IBC — Egress

2021 GROUP A PUBLIC COMMENT AGENDA

2021 Public Comment Agenda

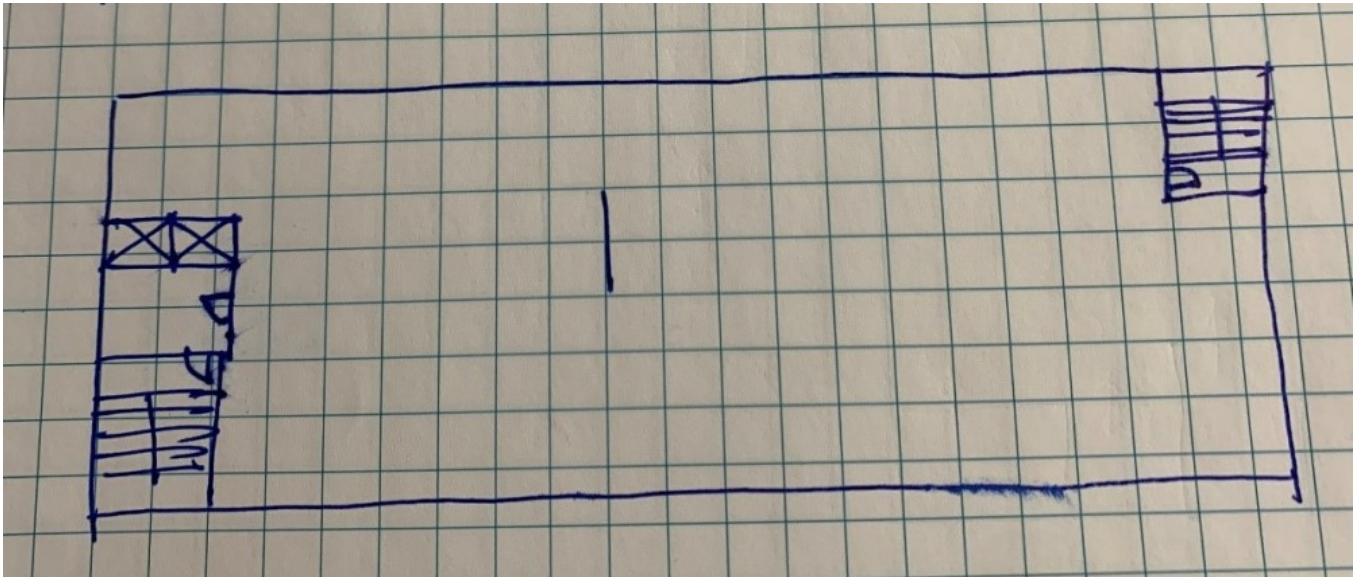
Example 1 is a three exit building with direct access from the elevator lobby to a stairway.

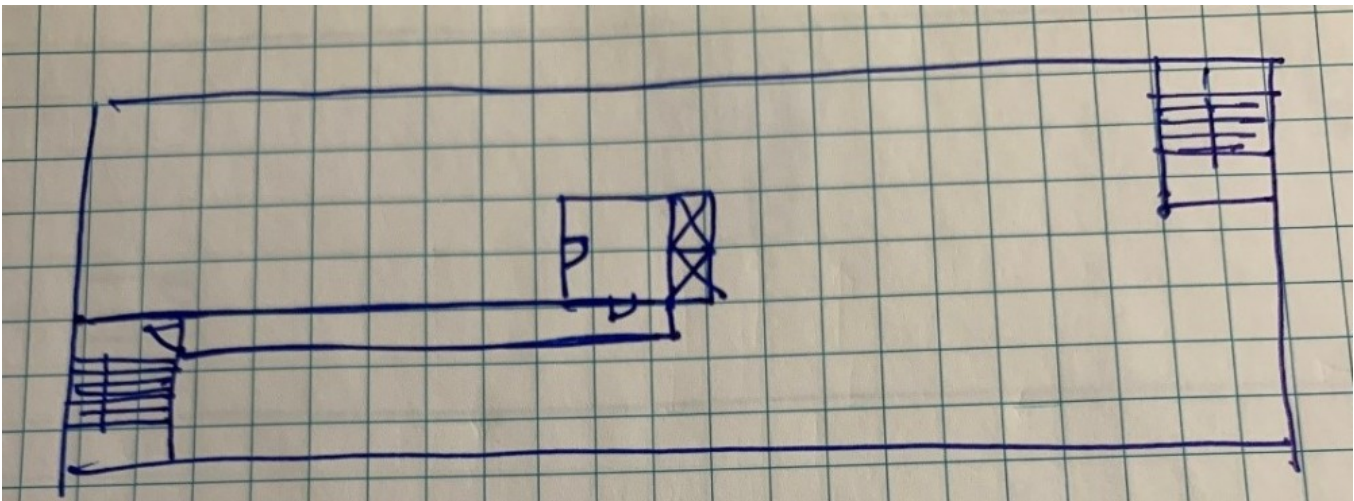
Example 2 is a two exit building with direct access from the elevator lobby to a stairway.

FIG.1

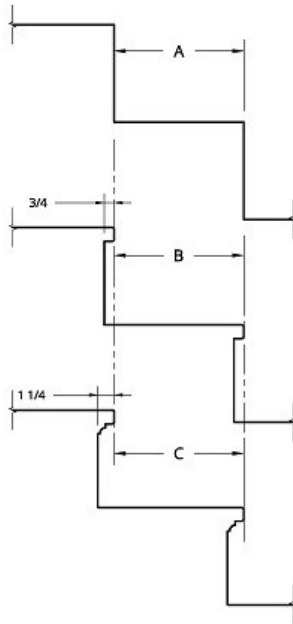
A NOSING PROJECTION ALLOWS THE FOOT TO BE PLACED FURTHER FORWARD AND PROVIDES MORE HEEL CLEARANCE IN DESCENT.

TREAD DEPTH A= NO NOSING PROJECTION
TREAD DEPTH B= MIN NOSING PROJECTION
TREAD DEPTH C=MAX NOSING PROJECTION

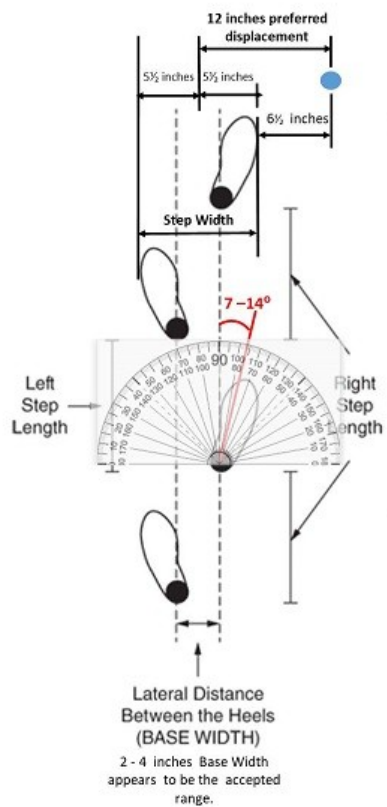
An offset of 6 inches from the limit of the walking surface to the center of the handrail is conservatively justified considering:

1. Data from B. Maki's static measurement of preferred lateral displacement.
2. Step widths shown in the tables below for older persons who widen their gait in an effort to stabilize as determined by Herrero-Larrea, A.

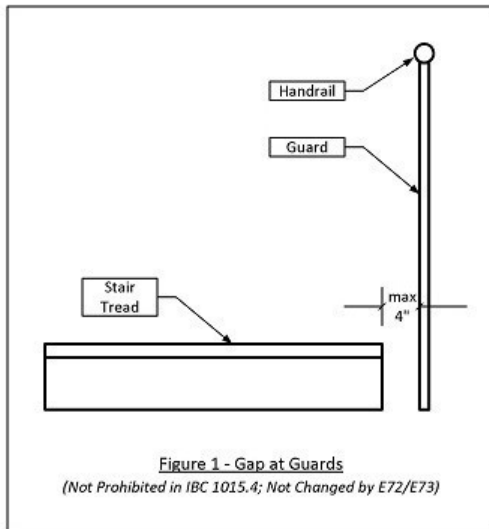
Photographic Examples. Photos 1, 2 and 3 below show the difficulty using a handrail that is 15 1/2" away from the edge of the walking surface. In all the photos, the person's arm is already fully- or over-extended, which is not comfortable for the user, nor is it safe if the person were to trip. You can see that this is an extreme example of what the code currently allows (i.e. not regulated). It's not a safe design but without language in the code that limits the handrail reach range, it's legal for the design professional to design it this way.

Photo 4 shows how the same child in Photo 3 can easily reach a handrail located 6" from the edge of the walking surface (note the bent elbow). The wood handrail in this photo is at approximately the same height as the handrail that is in the background, which is 15-1/2 inches from the edge of the stair. This shows 6" is a reasonable and safer limitation for the handrail placement, even for a small child.

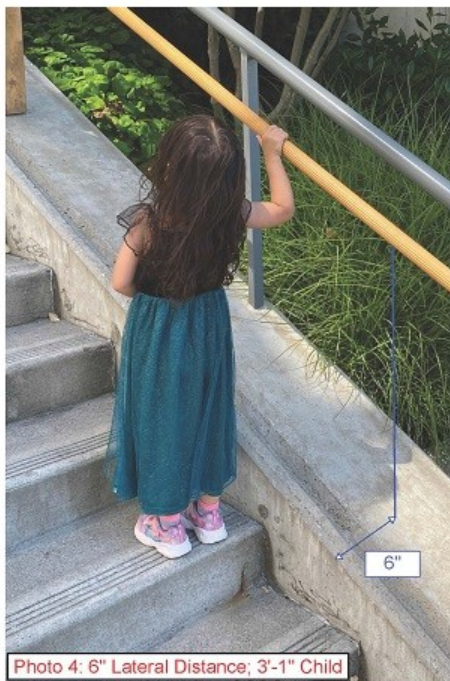
Photographic Examples. Photos 1, 2 and 3 below show the difficulty using a handrail that is 15 ½" away from the edge of the walking surface. In all the photos, the person's arm is already fully- or over-extended, which is not comfortable for the user, nor is it safe if the person were to trip. You can see that this is an extreme example of what the code currently allows (i.e. not regulated). It's not a safe design but without language in the code that limits the handrail reach range, it's legal for the design professional to design it this way.

Photo 4 shows how the same child in Photo 3 can easily reach a handrail located 6" from the edge of the walking surface (note the bent elbow). The wood handrail in this photo is at approximately the same height as the handrail that is in the background, which is 15-1/2 inches from the edge of the stair. This shows 6" is a reasonable and safer limitation for the handrail placement, even for a small child.

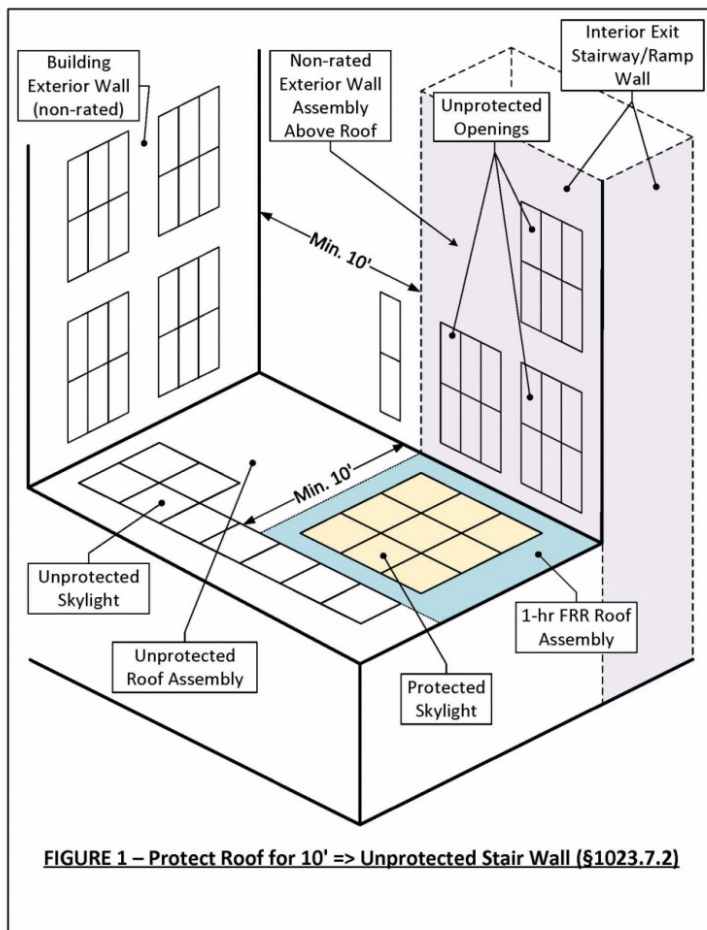
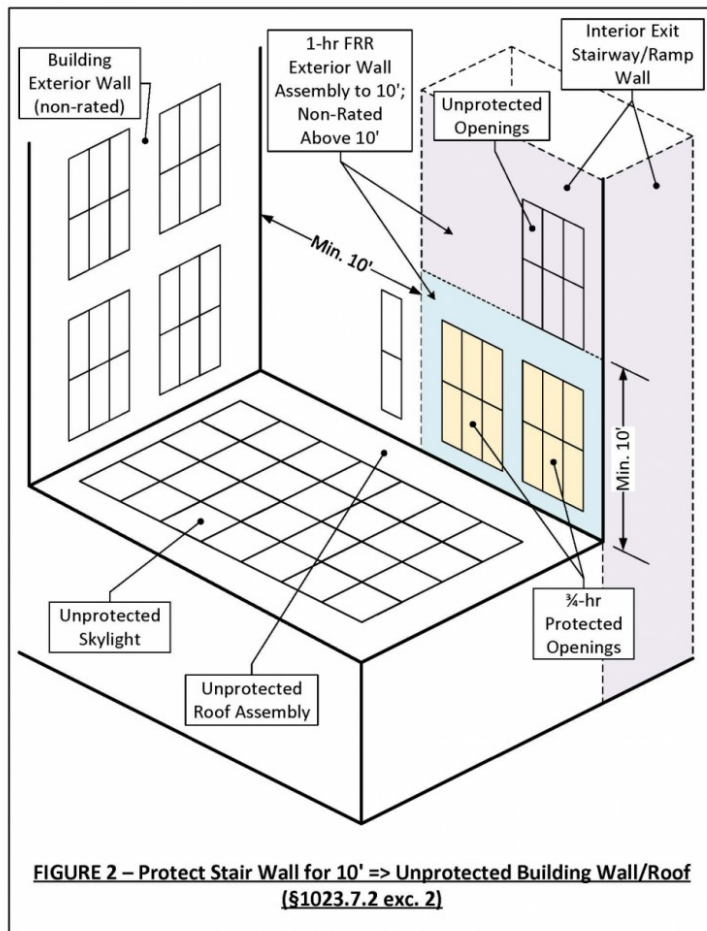
- 1) clear language that either the exterior wall and openings of the enclosure must be protected or protect the adjacent building wall and/or roof assembly (see Section 1023.7.2, Exception 2, and Figures 1 and 2 below);
- 2) clarify in the charging language of Section 1023.7.2 that the protection of roof assemblies only applies when it is part of the same building in which the enclosure is located; and
- 3) exempt roof assemblies adjacent to penthouse structures covering stair or ramp enclosures (see Section 1023.7.2, Exception 1).

Figure 1 below illustrates the base requirement in Section 1023.7.2, that the roof assembly and openings in the roof must be protected within 10 feet of the wall of the stairway or ramp enclosure. Figure 2 illustrates the option provided in Section 1023.7.2, Exception 2, allowing protection of the stairway/ramp enclosure wall to a height of 10 feet above the adjacent roof in lieu of protecting the roof assembly. These figures, or something similar, could be included in the IBC Commentary to help code users understand and apply these important passive life safety provisions.

Transfer shower

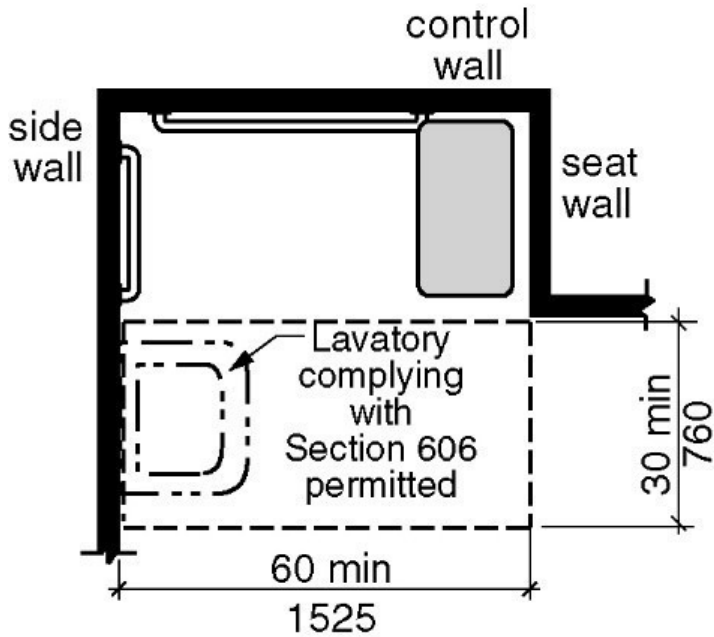
Reason: If a hotel has all showers, Table 1107.6.1.1 could be read to force bathtubs in Accessible rooms. What is the reasoning/justification for this? A roll-in shower with a seat is doing double duty as transfer and roll-in. The table was written originally with the intent to require at least some roll-in showers when hotels typically provided all bathtubs. Designs for bathrooms have changed. Providing showers instead of tubs has been shown to reduce accidental falls in the bathrooms; while continuing to provide accessible options.
